DUGGAN MORRIS ARCHITECTS

job title					
BARTRAM'S HAMPSTEAD					
drawing title/location					
BASEMENT FLOOR PLAN					
status		PLANNING			
scale		1:100@A1	1:200@A3		
job no	source	zone	element	drawing no.	revision
A213	A		(01)	1 01	B

drawing title/location
LOWER GROUND FLOOR PLAN

drawing title/location
SIXTH FLOOR PLAN

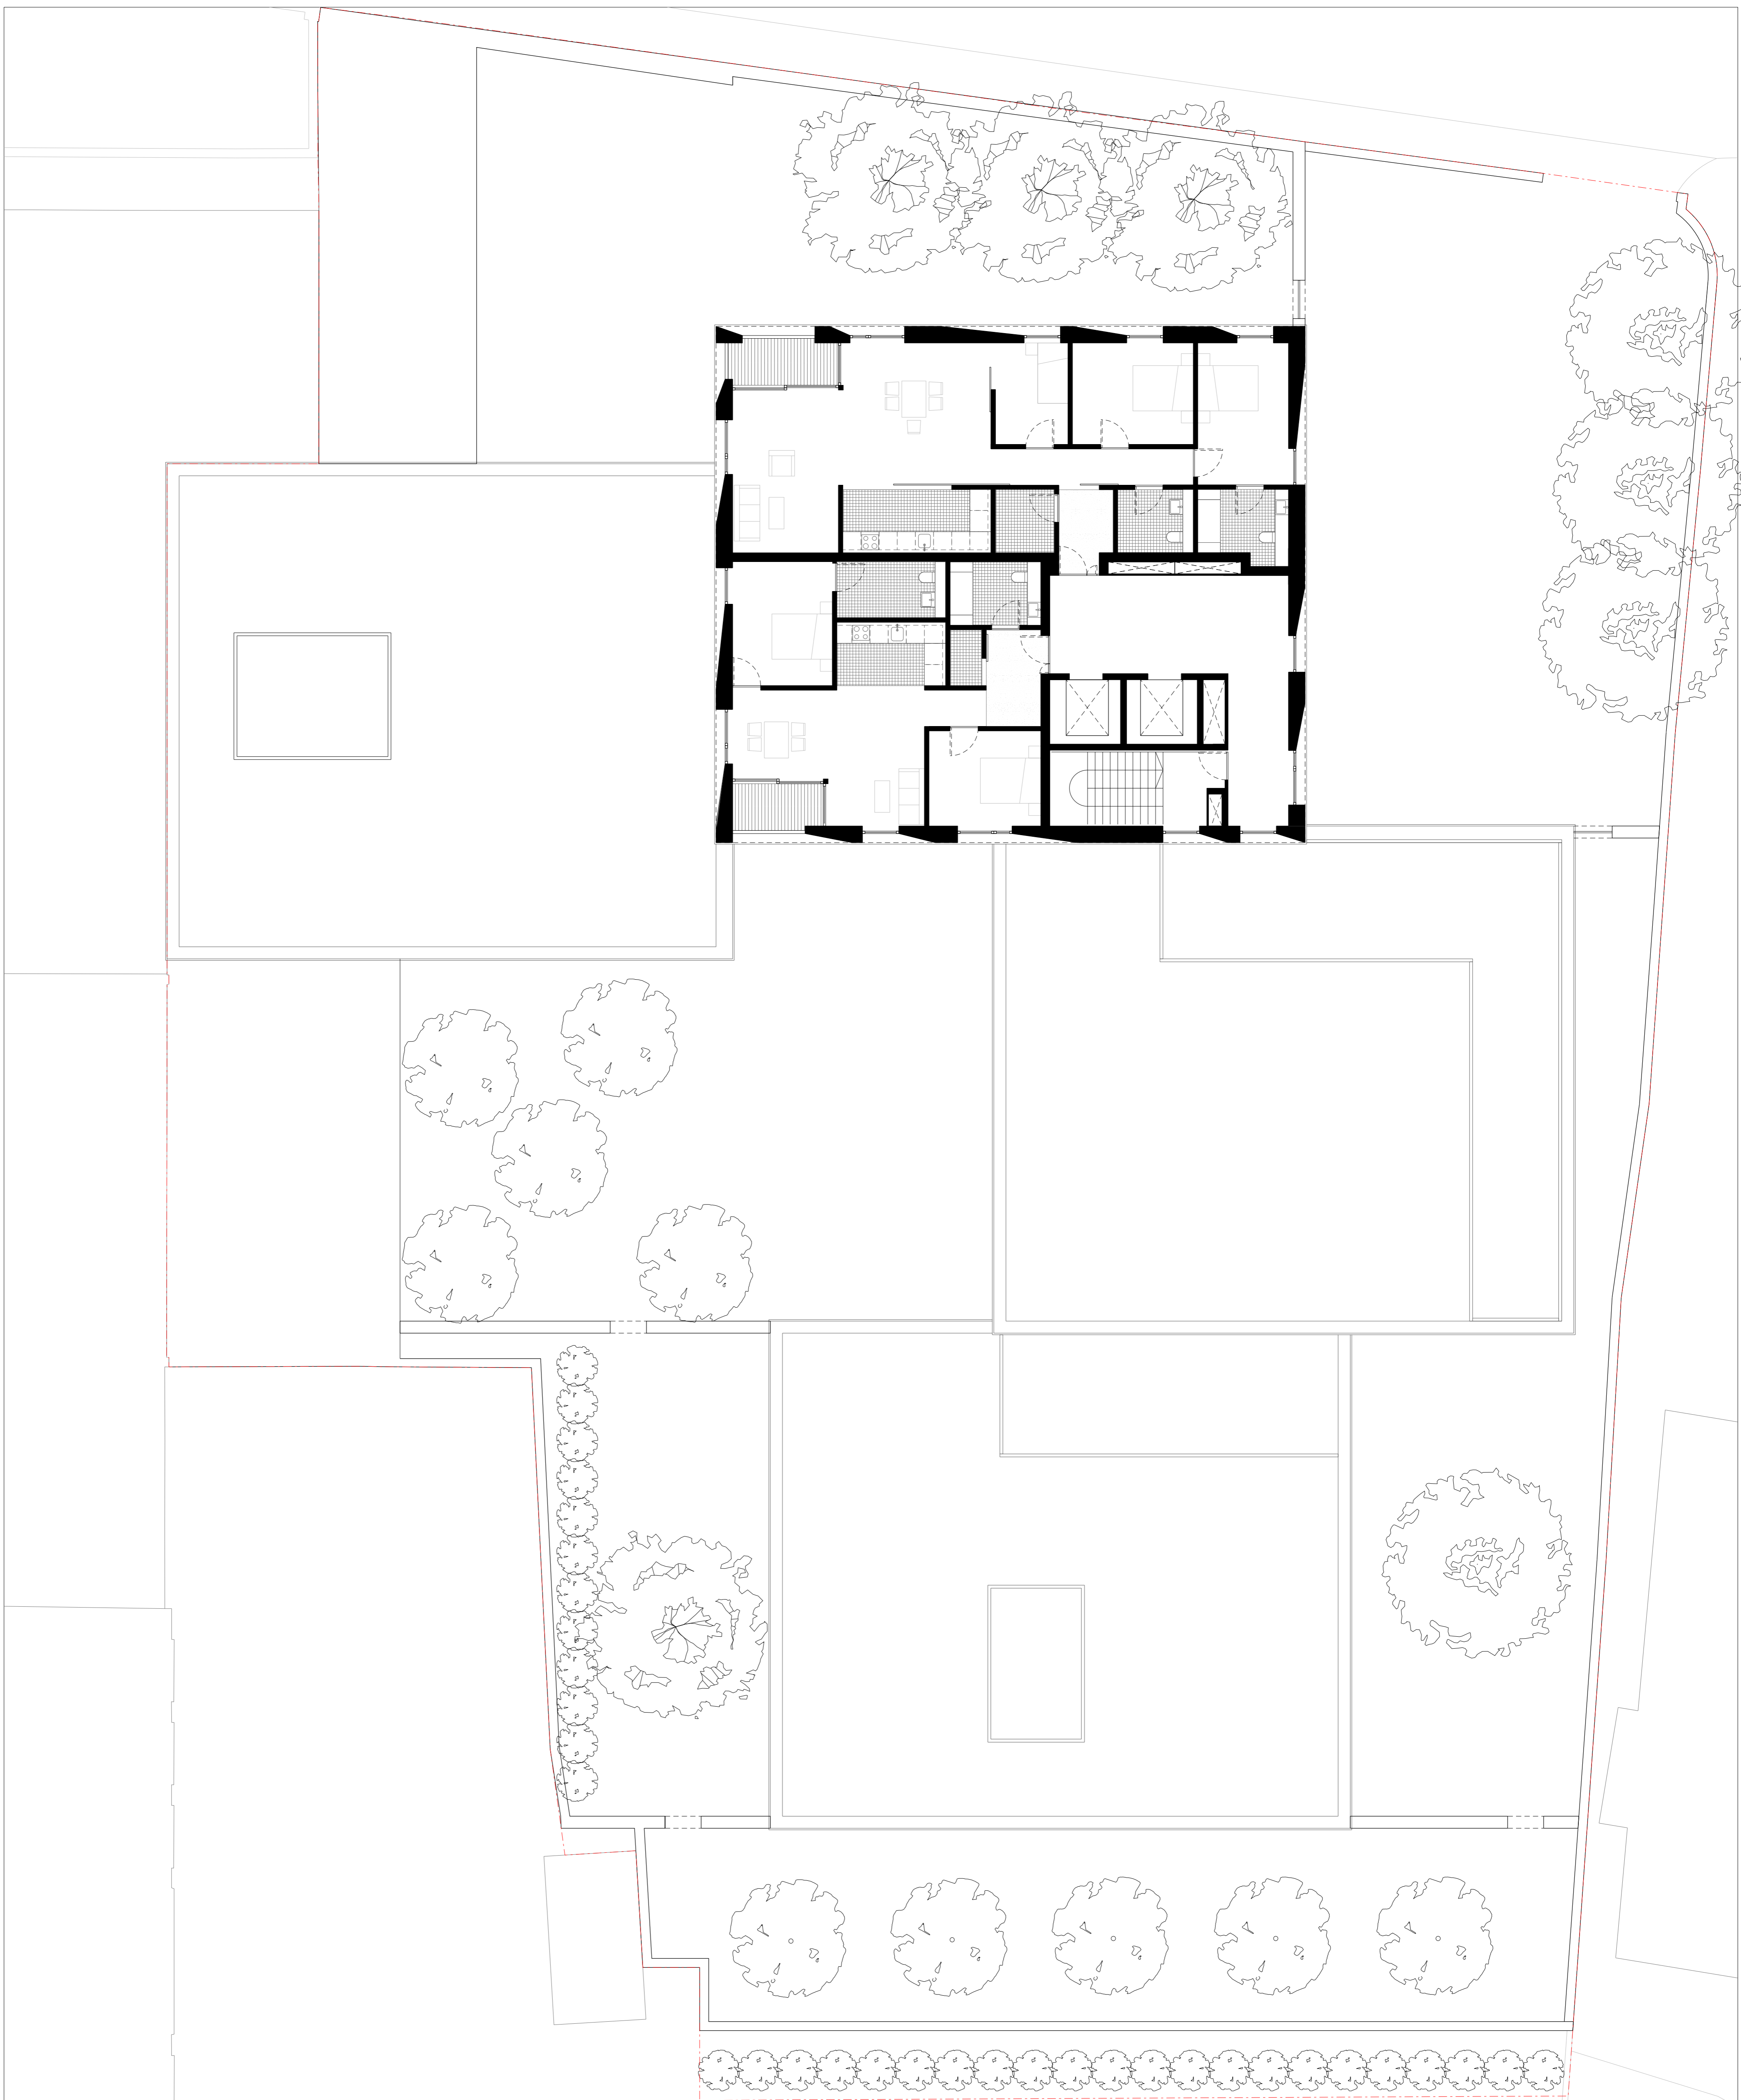
revision	date	amendment
A	10.04.15	Lift car amended to 1850mm x 1400mm
/	01.10.14	Submitted to planning

drawing title/location
SEVENTH FLOOR PLAN

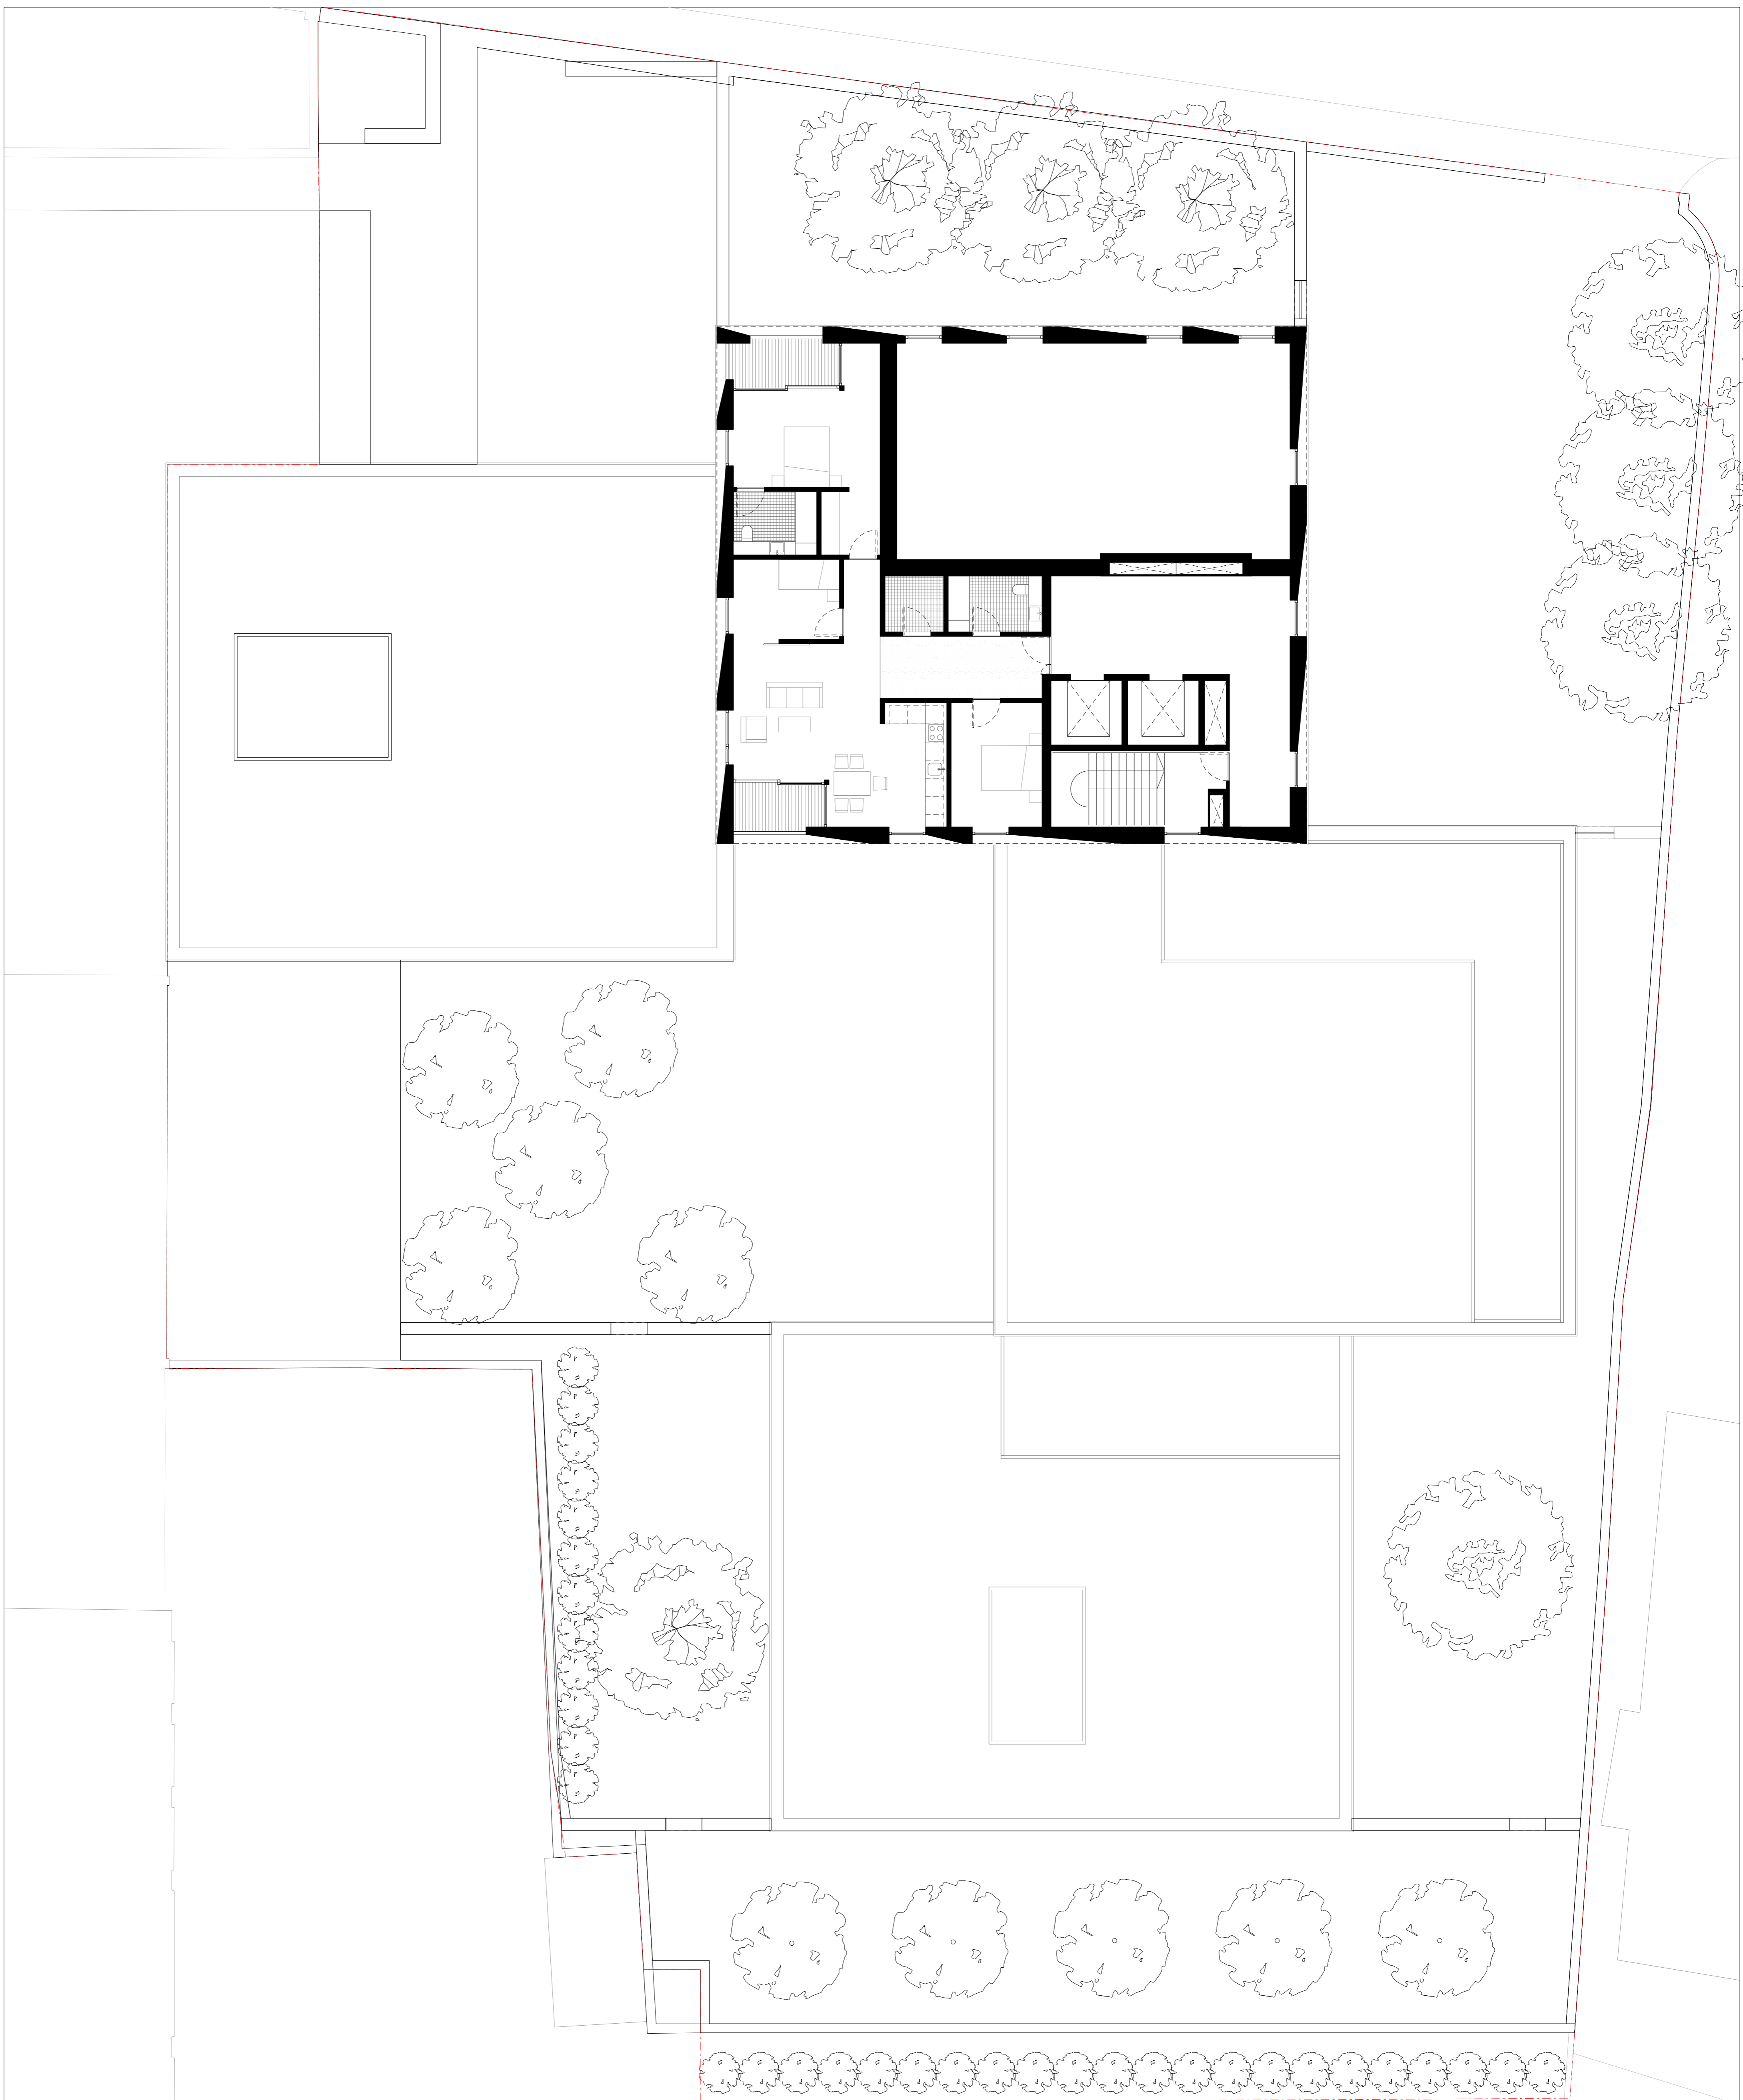
revision	date	amendment
A	10.04.15	Lift car amended to 1850mm x 1400mm
/	01.10.14	Submitted for planning

EIGHTH FLOOR PLAN

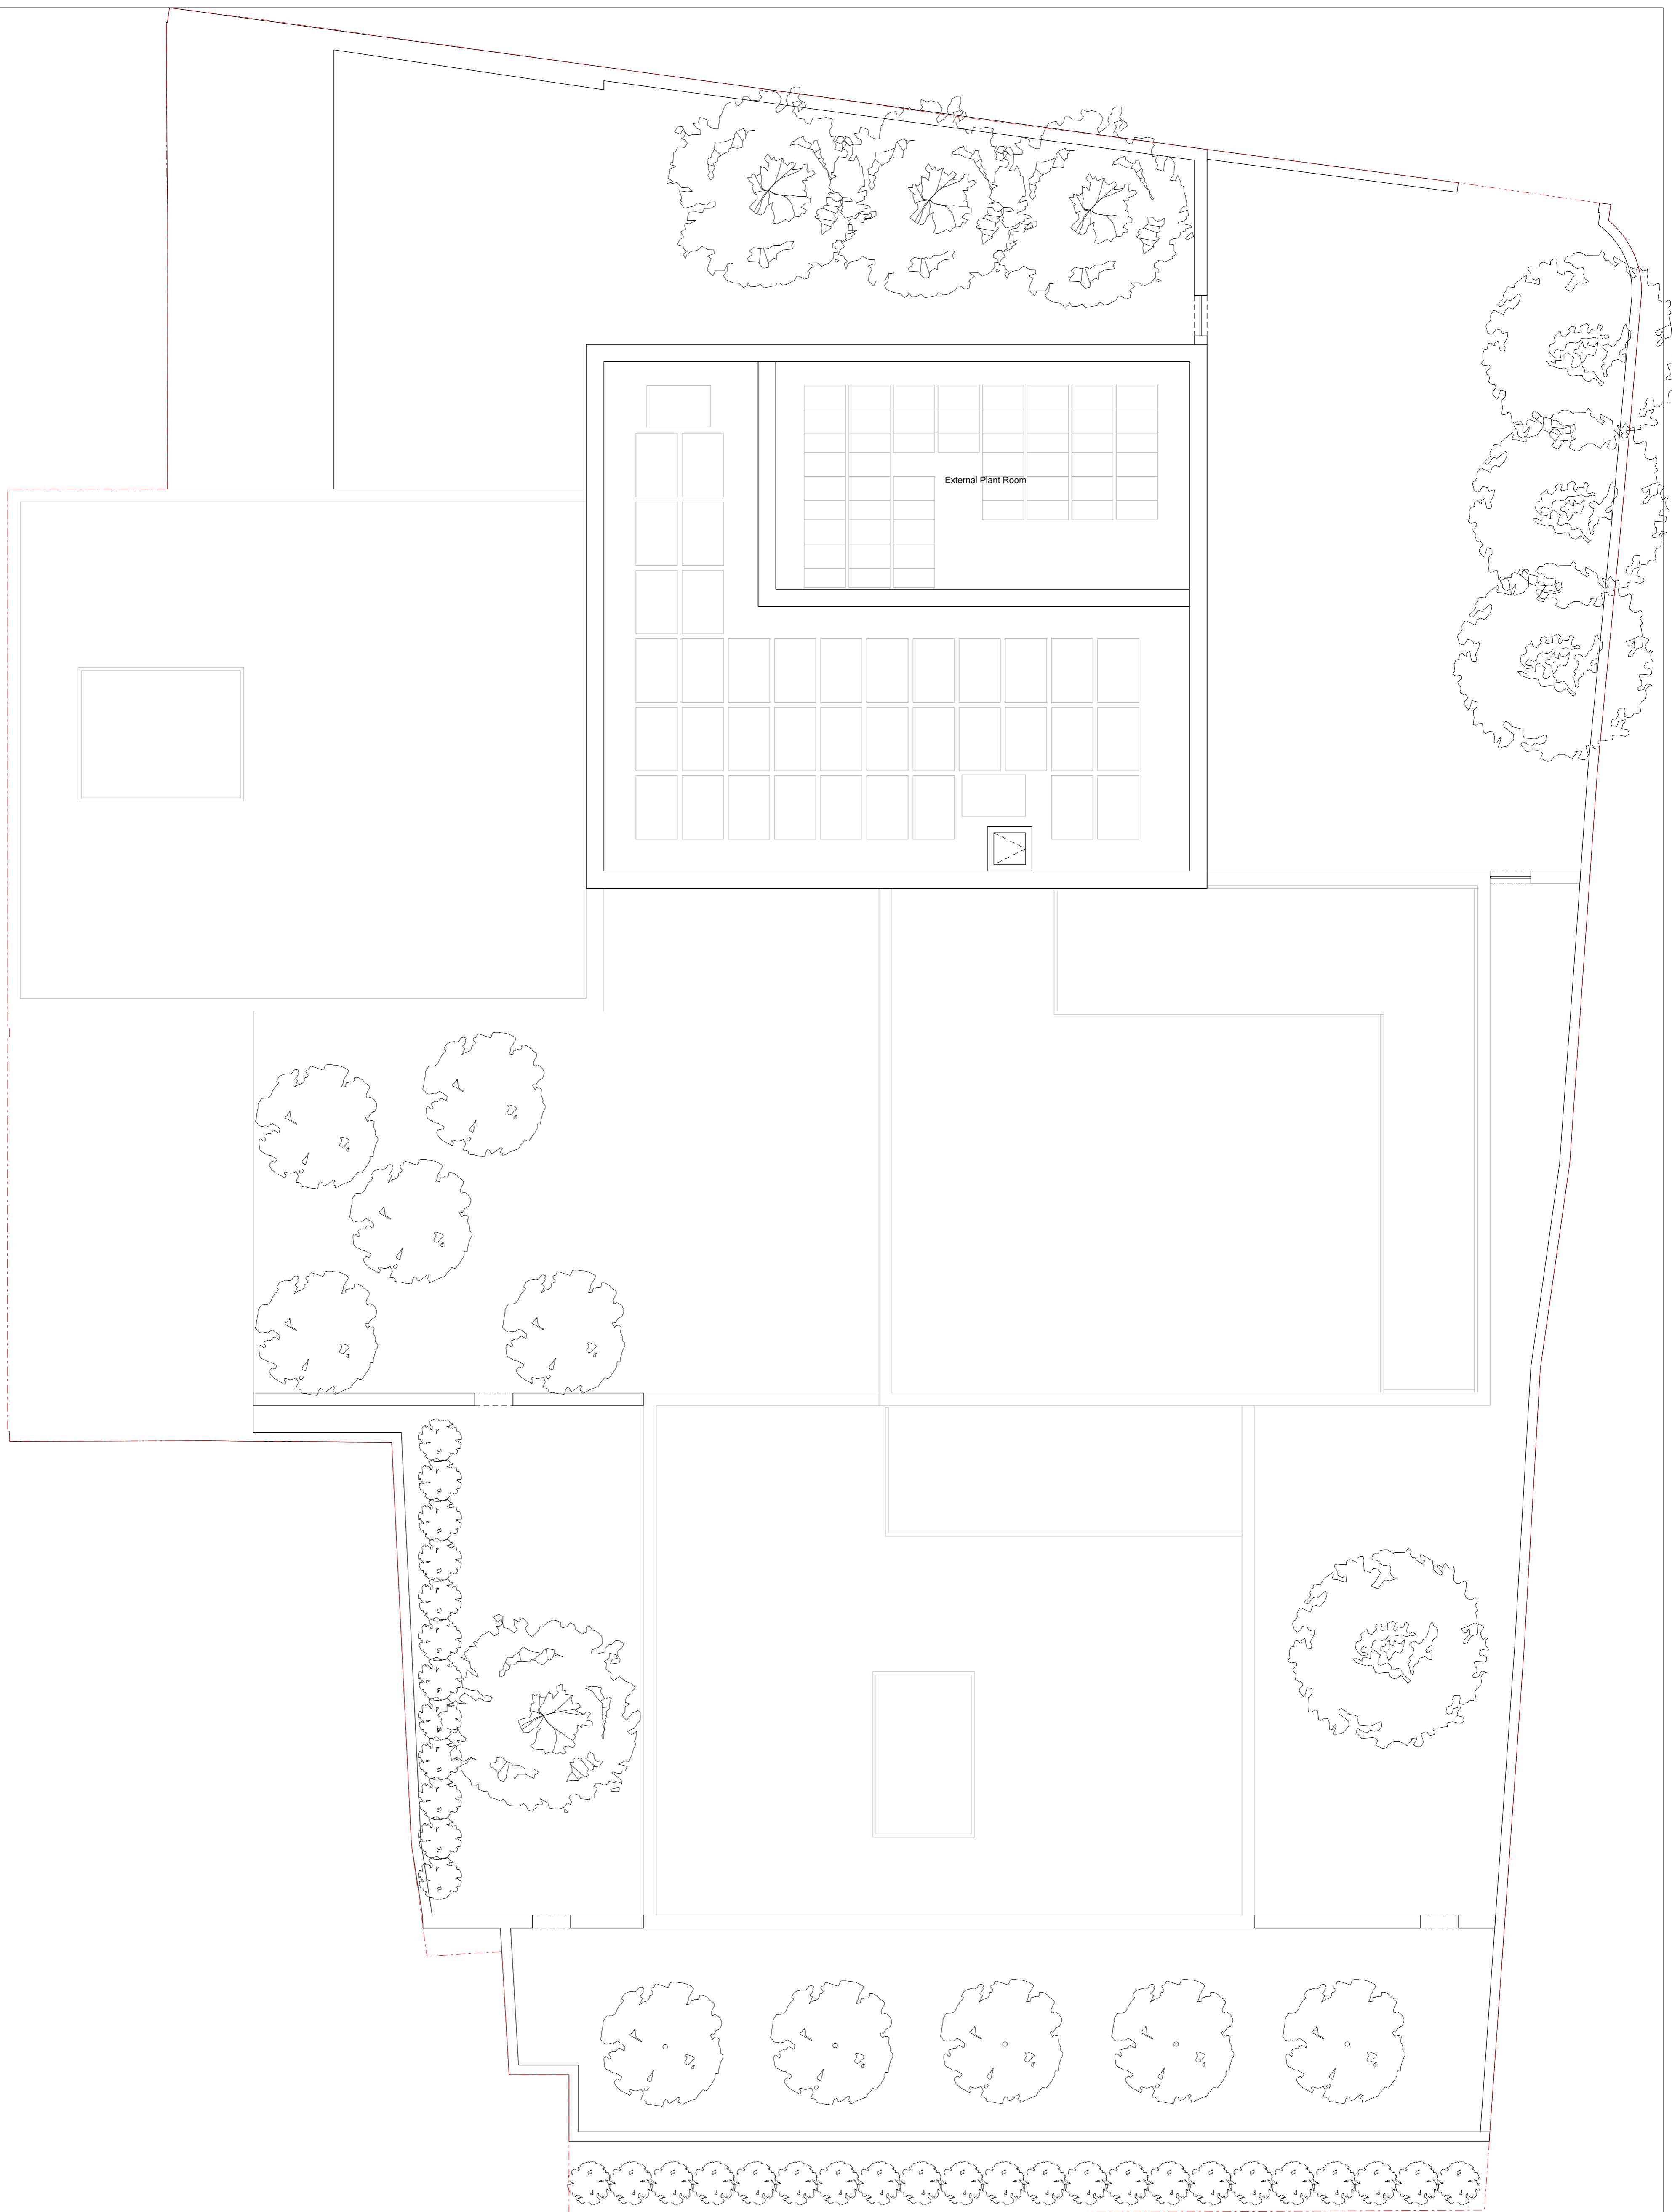
revision	date	amendment
A	10.04.15	Lift car amended to 1850mm x 1400mm
/	01.10.14	Submitted for Planning
